**International Uranium (USA)
Corporation**

**SOURCE MATERIALS LICENSE
SUA-1358, DOCKET No. 40-8681**

**Additional Clarifications to
White Mesa Mill Reclamation Plan**

Re: Source Materials License SUA-1358, Docket No. 40-8681
Additional Clarifications to White Mesa Mill Reclamation Plan

International Uranium (USA) Corporation White Mesa Mill			
Sections D-D' & E-E' from Figure A-5-1 of Reclamation Plan			
DESIGN	BAH	DRAWN	BAH
CHKD BY		DATE	4/2/89
APP		SCALE	as shown

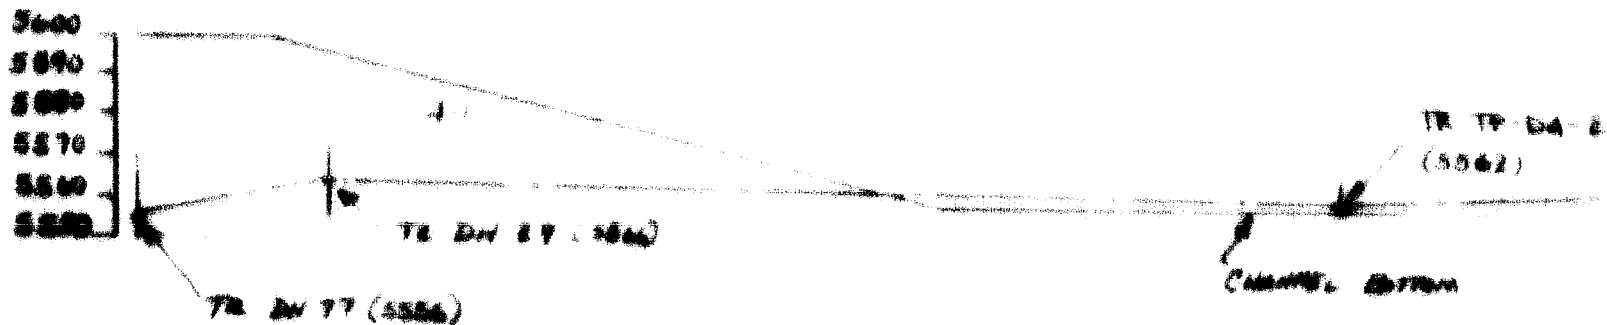
- 4) Sections D and E to Figure A-5.1-1, details the cross sections to the breach of Cell 4A Dike.
- 5) Revised Rational Method Calculation of PMF Peak Discharge, Velocity, Depth, and Scour through Cell 4A Breach, with breach widened to 200 feet.
- 6) Revised details to the Rock Apron at Toe of Cell Outslope. This drawing has been previously submitted to the NRC in response to Question 19 of the August 28, 1998 Submittal to NRC.
- 7) Results of a rerun of the Radon Emanation Calculations to take into account revisions to inconsistent variables and more conservative approach to the assumptions used in cover design, as per NRC staff suggestions,

A ROCK APRON AT TOE OF CELL OUTSLOPE
NTS

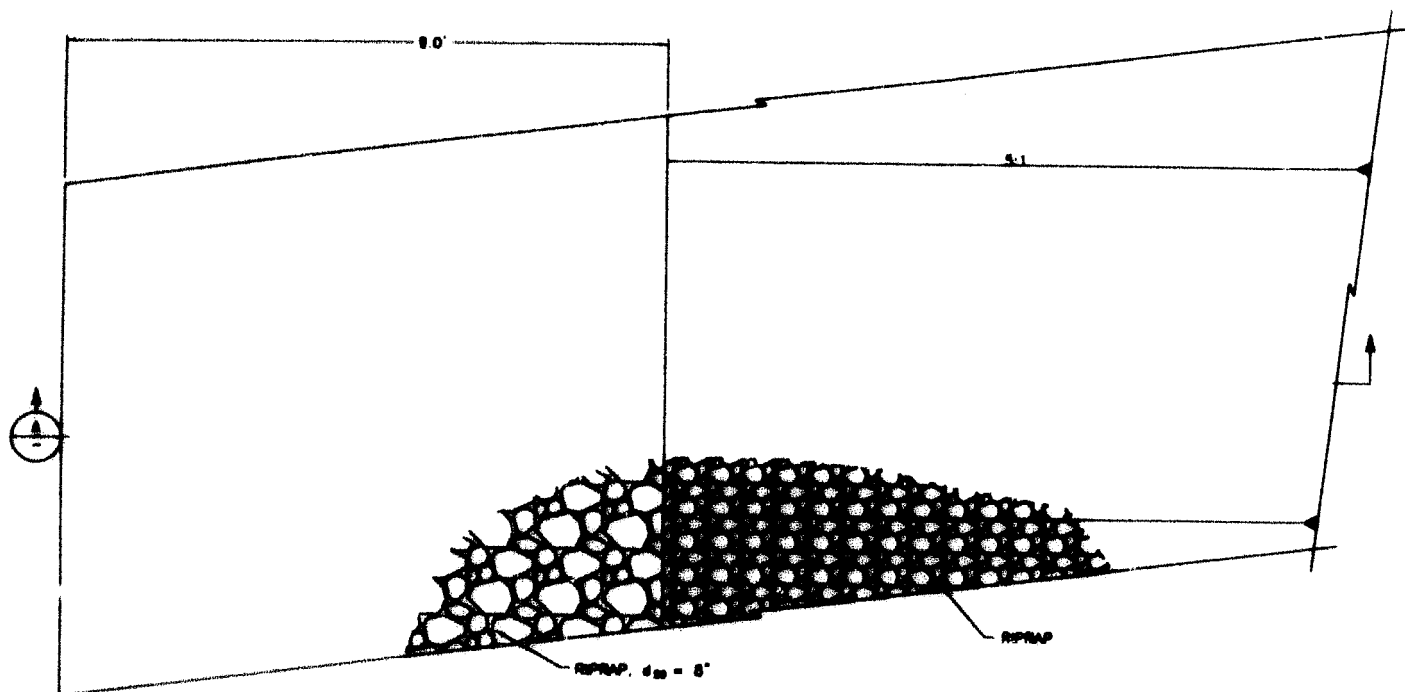
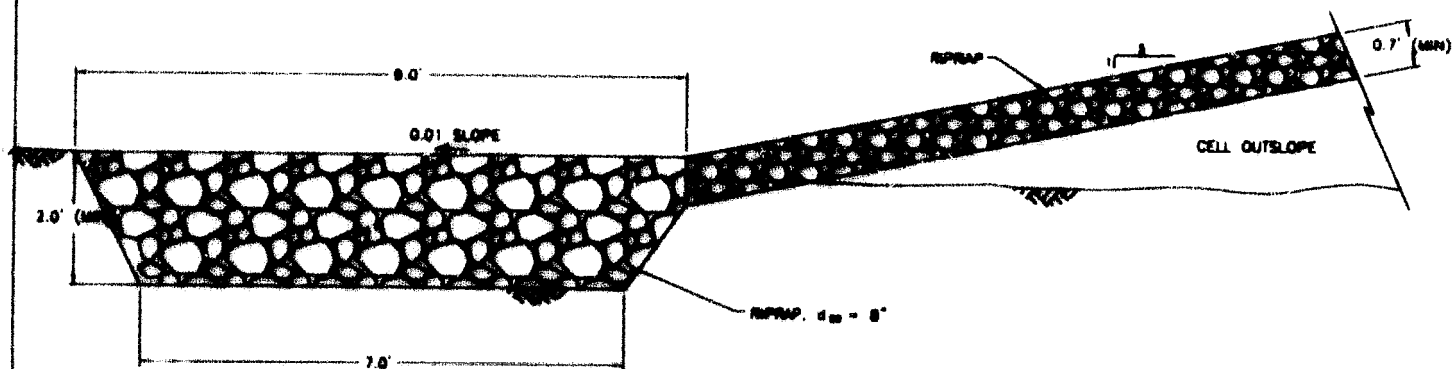
RATIONAL METHOD CALCULATION OF PMF PEAK DISCHARGE, VELOCITY, DEPTH AND SCOUR THROUGH CELL 4A BREACH WITH BREACH WIDENED TO 200 FEET IUC WHITE MESA

Breach Bottom Width B	Breach Side Slopes	Breach Channel Gradient S	Manning Coeff n	Gravel 48" x 5	Flow Depth y ft	Cross Section Area of Flow A ft ²	Hydraulic Radius R ft	a(R) ^{1.48}	Velocity v fps	Adverse Peak velocity fps (COE 1970)	Riprap Size 150 inches (ft)
Soil (BM) Channel	200	3:1	0.0073	0.03	1.38	283.8	1.36	348.59	5.20	2.4	4.00
Rock Channel	200	3:1	0.0073	0.025	2.91	254.7	1.23	291.78	5.82	8-10	N/A
